CLAS12 RICH Project Midterm Status

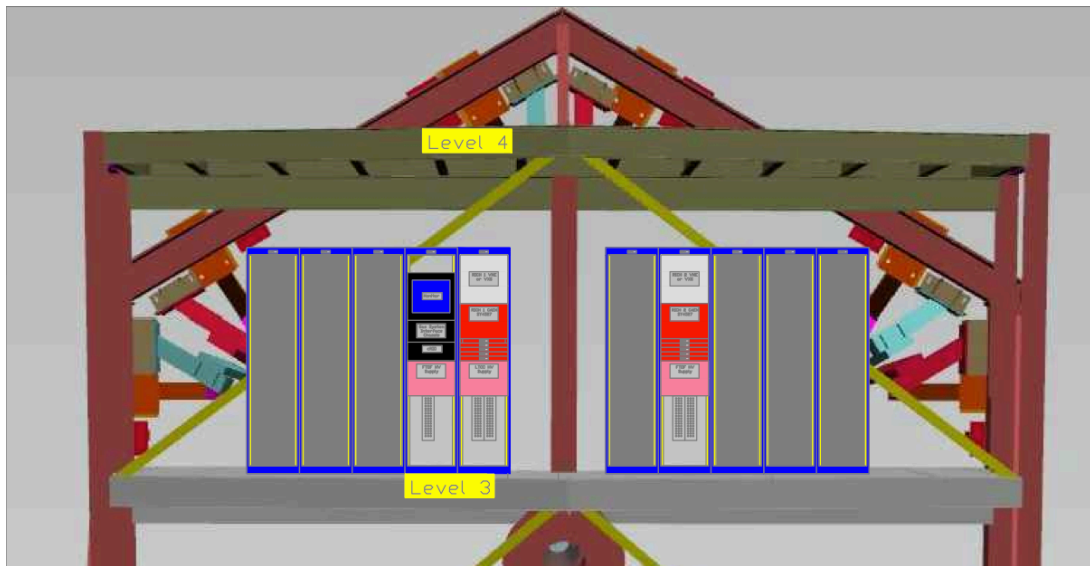
4. The air-cooling and nitrogen gas systems are pressure systems and approvals from the Pressure Systems design authority are required before operation.

The Pressure System design has been approved as part of OSP ???
